AMENDMENTS TO THE DRAWINGS:

REMARKS

This communication is a full and timely response to the aforementioned non-final Office Action dated July 17, 2006. Claims 1-31 are pending. Claims 13, 14, and 24-31 have been withdrawn from consideration. Pursuant to MPEP § 821.04(b), once Claims 1 and 15, which are directed to a substrate support, are found allowable, Applicant respectfully requests that withdrawn process Claims 13, 14, 24, and 25, which depend from Claims 1 and 15, be rejoined with the elected subject matter. Reconsideration and allowance are respectfully requested in view of the following remarks.

FIG. 2

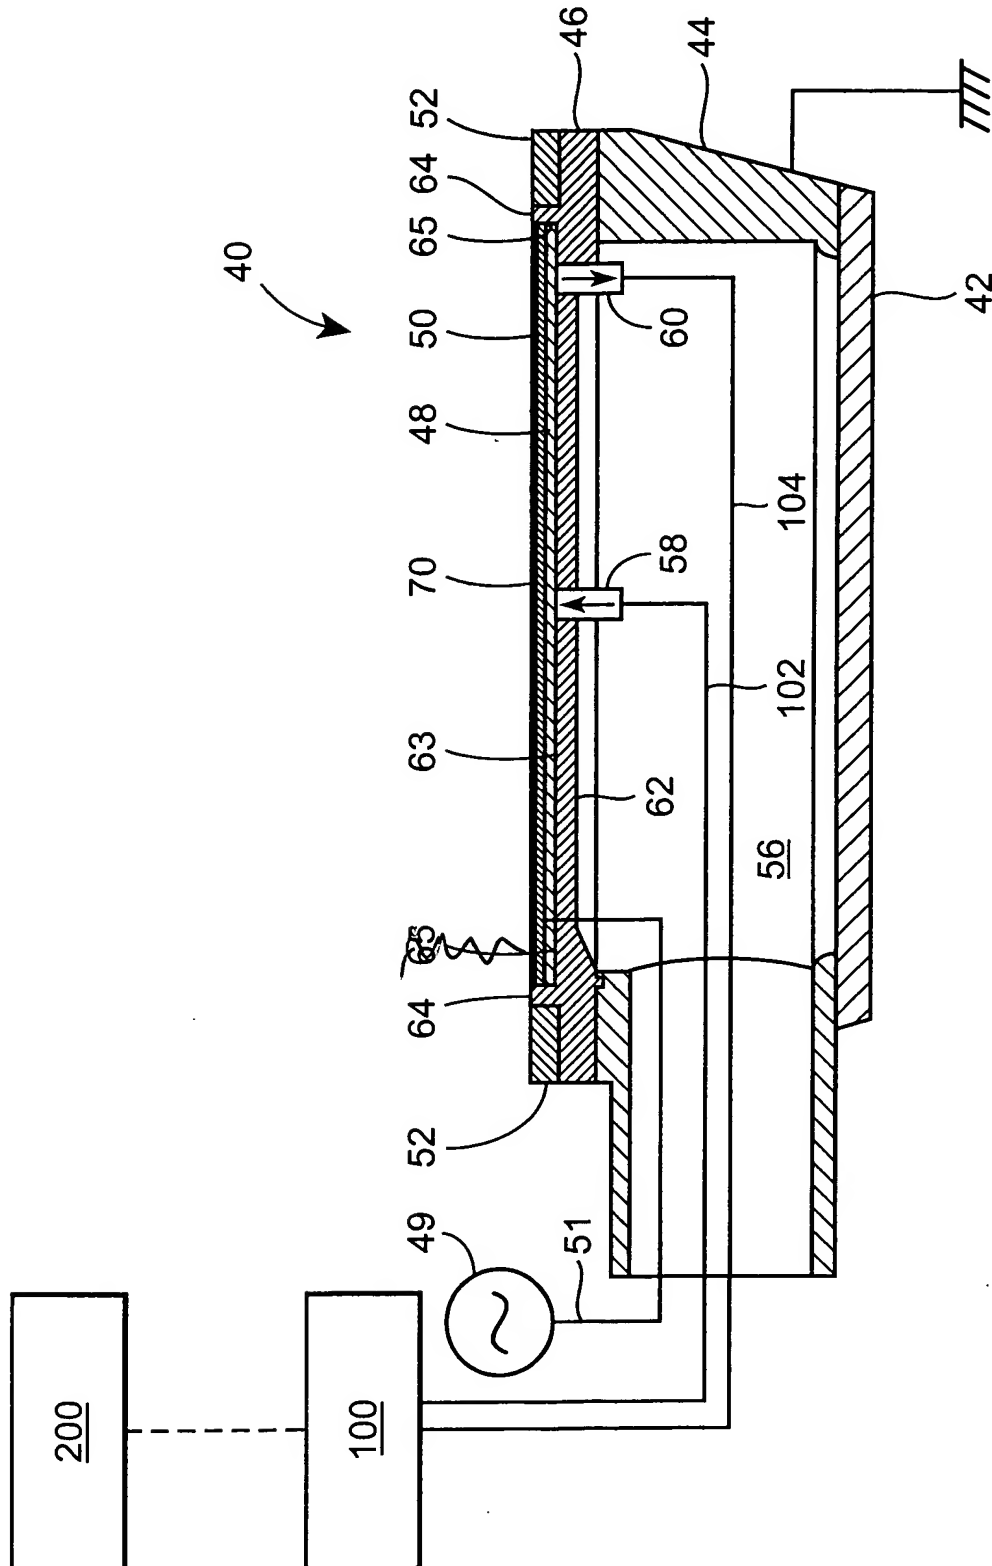
The Official Action objects to the drawings under 37 C.F.R. § 1.84(p)(5). In the Replacement Sheet for FIG. 2, submitted herewith, the reference number "65" and an associated lead line have been deleted. As such, Applicant respectfully requests the withdrawal of the objection.

The attached sheet of drawings includes changes to FIG. 2. This sheet, which includes FIG. 2, replaces the original sheet including this same figure. In FIG. 2, reference number "65" and an associated lead line are deleted.
